[Miscellaneous Crandon Project correspondence]. 1984-1985

On December 29, 1983, the Department of Natural Resources (DNR) sent Exxon Minerals Co., the second of several detailed letters reviewing Exxon's Environmental Impact Report (EIR) for their proposed zinc-copper mine near Crandon. Comments in this second letter supplement the first letter sent to Exxon May 11, 1983. The EIR was submitted December 22, 1982, and additional technical information continues to be received and reviewed.

Status Report of
Department of Natural Resources Activities on the
Proposed Exxon Mine near Crandon, Wisconsin

FIGURE 1

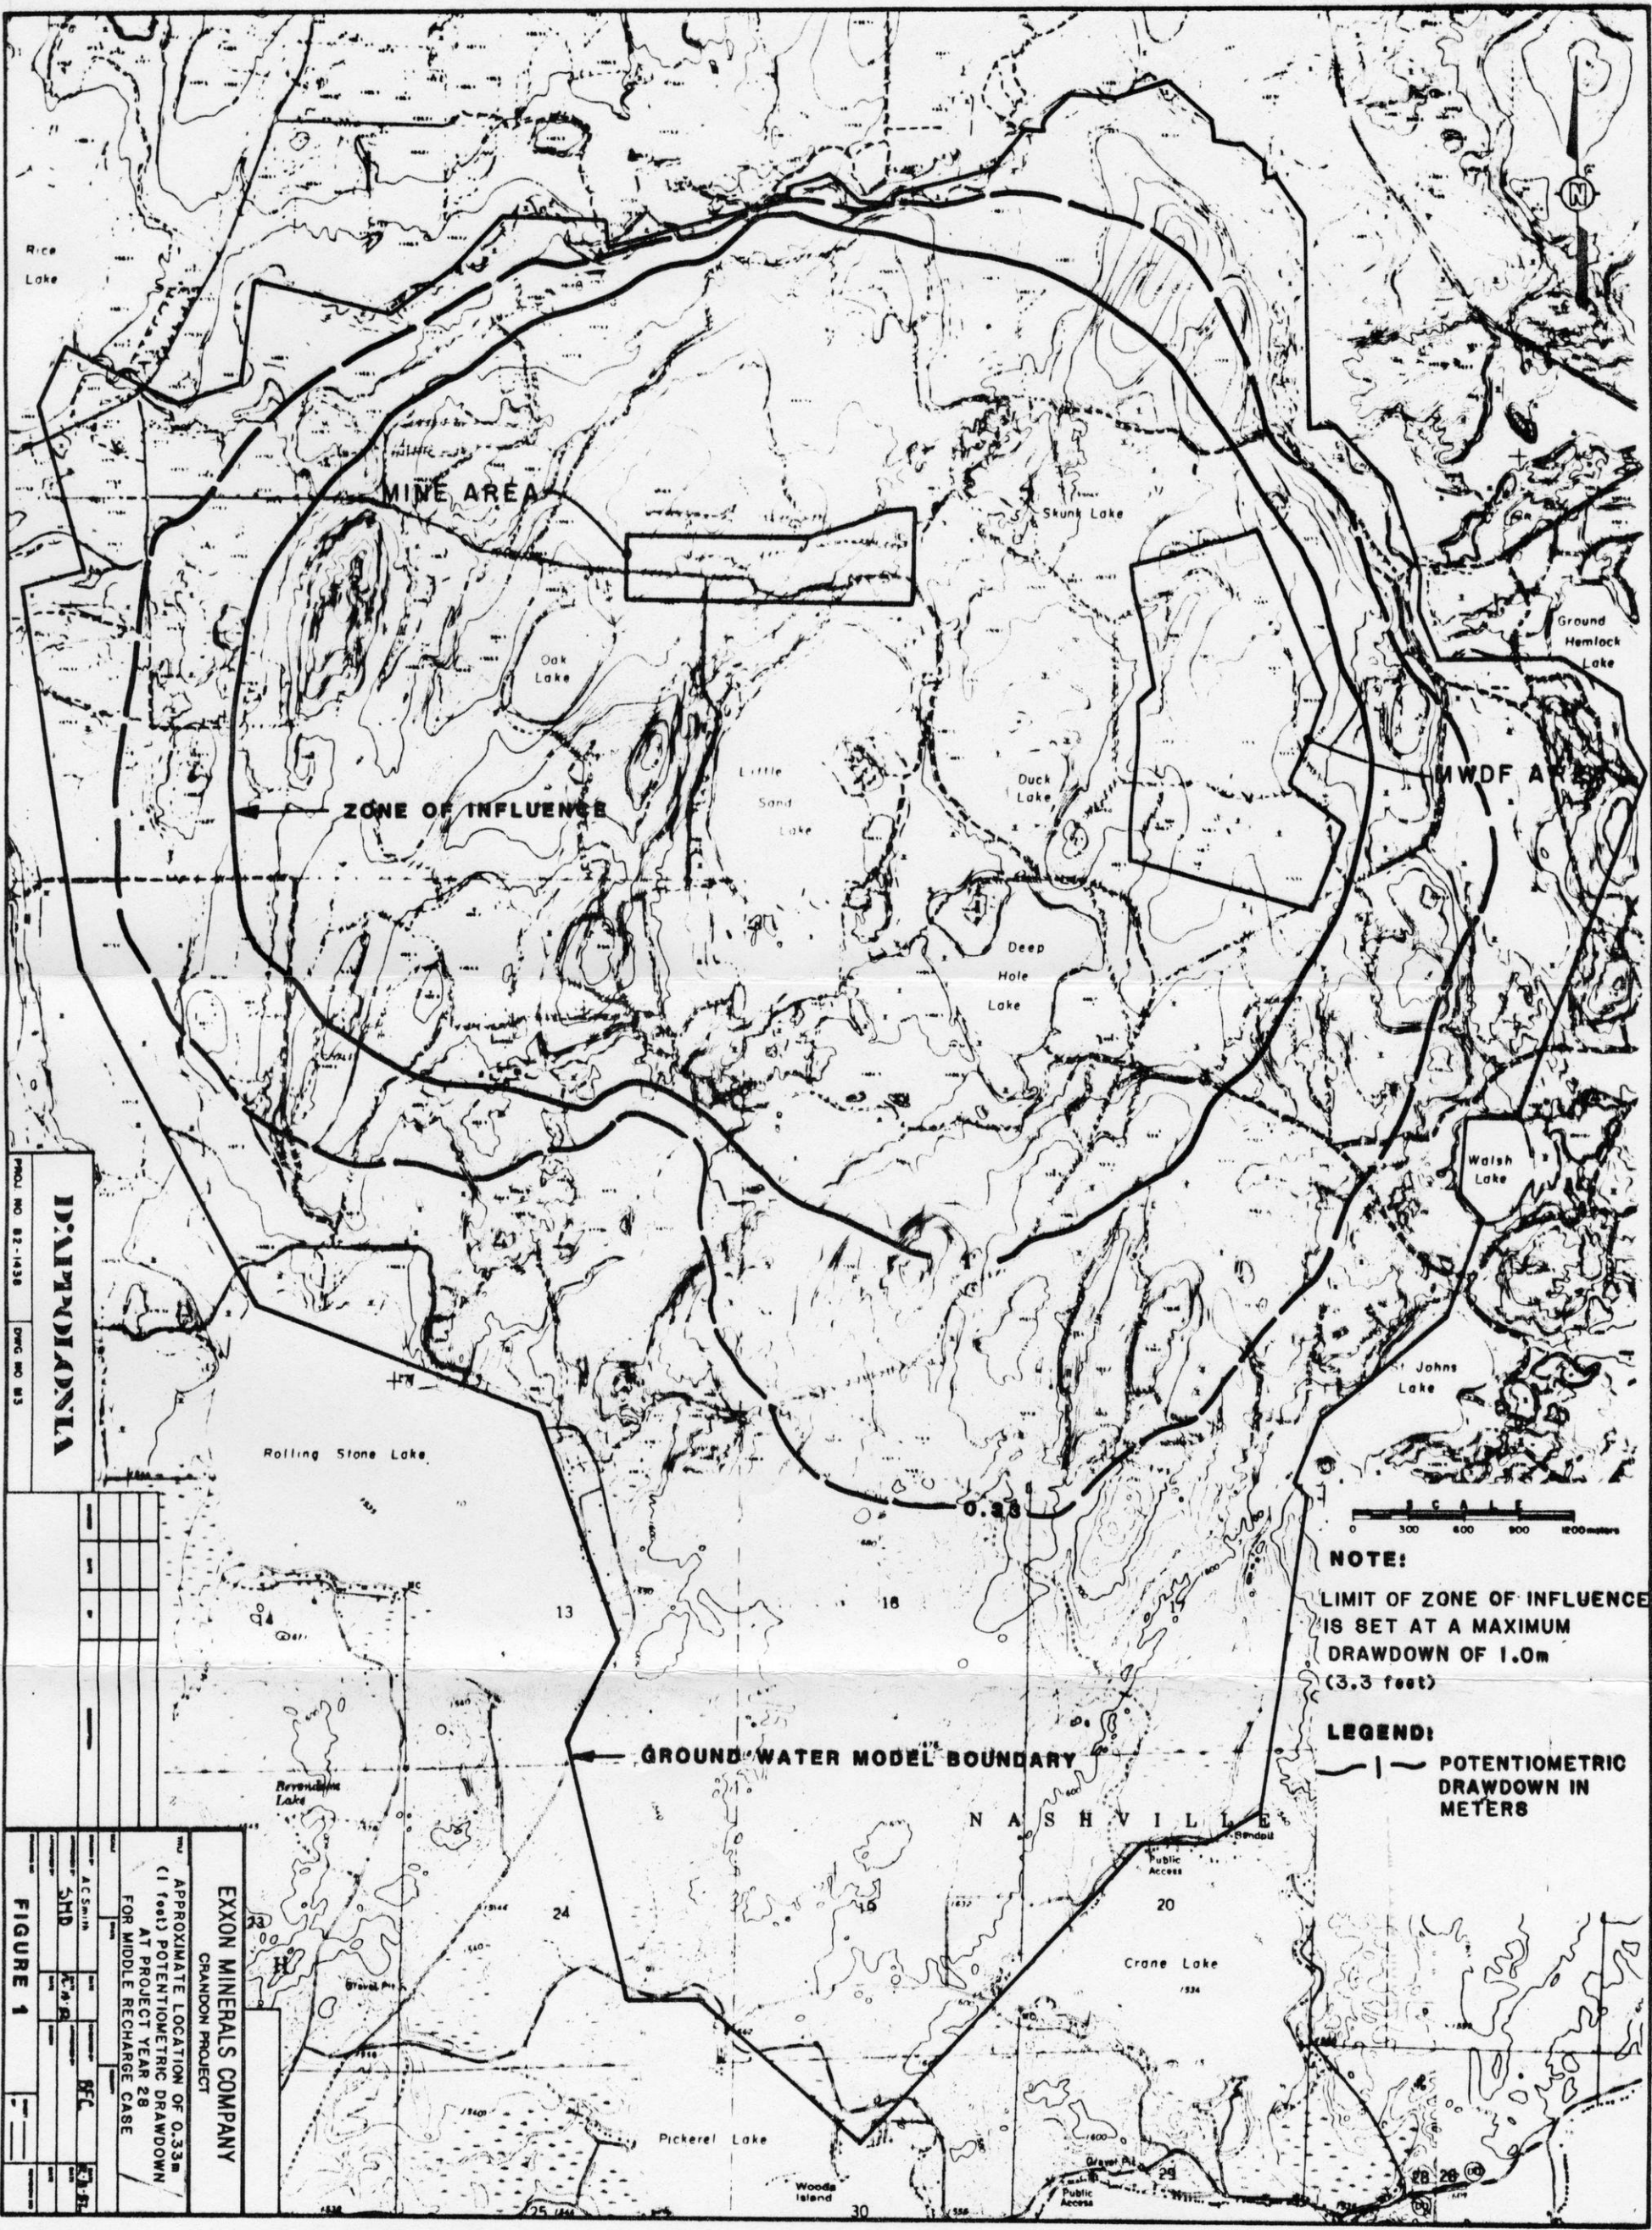
Attached Figure 1 depicts the locations of the 1 m (3.3 foot) and 0.33 m (1.0 foot) drawdown contours at Project year 28 for the expected mine inflow value for the middle recharge case (8.5 inches). Project year 28 has been used in EIR Appendix 4.1.A to portray steady-state conditions for mine inflow and ground water drawdown effects. Other study work associated with the preparation of Appendix 4.1.A determined that the drawdown changes were approximately the same for all three (low, middle, and high) recharge cases.

In addition to the question of accuracy for the small drawdown values from the mine inflow, these changes have to be superimposed on a ground water surface that is constantly fluctuating in position from normal influences. Our studies have indicated that the ground water surface normally fluctuates to over 1.0 m (3.3 feet) in the upland areas of the site to smaller values (0.2 m [0.7 feet]) or less

Figure 26-H. Air blast overpressure as a function of distance and charge weight for the unconfined and confined charges. P is expressed in psi, R in feet, and W in pounds.

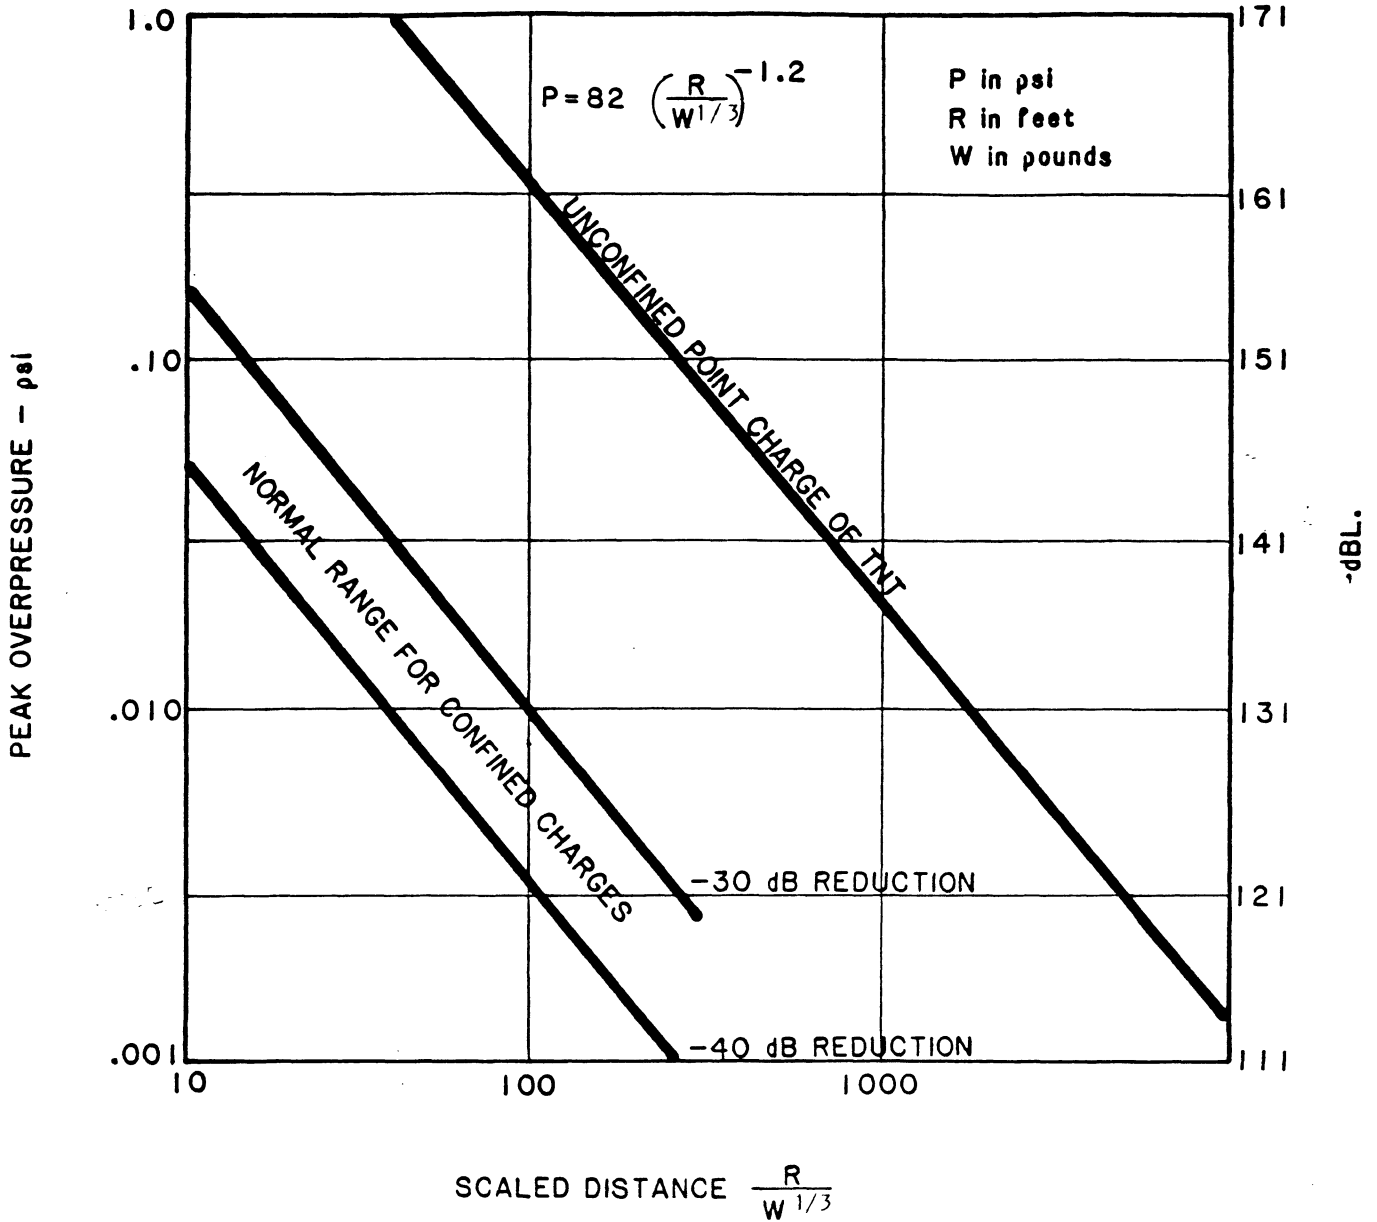
Alan Haas, Howard, Needles, Tammen and Bergendoff, requested clarification of the example calculations and the figure presented in part 2) Blasting, of the response. The basis for the example calculations and the relationship to the figure are more fully explained in this revised response. The other parts of this response have not been changed.

- a. For the start of main shaft blasting at the 34-m (110-foot) depth (i.e., the glacial soil [overburden] and bedrock interface), attached Figure 26-H:

- b. For the middle of main shaft blasting at a 435-m (1425-foot) depth, from attached Figure 26-H:

- c. For the bottom of main shaft blasting at the 837-m (2745-foot) depth, from attached Figure 26-H:
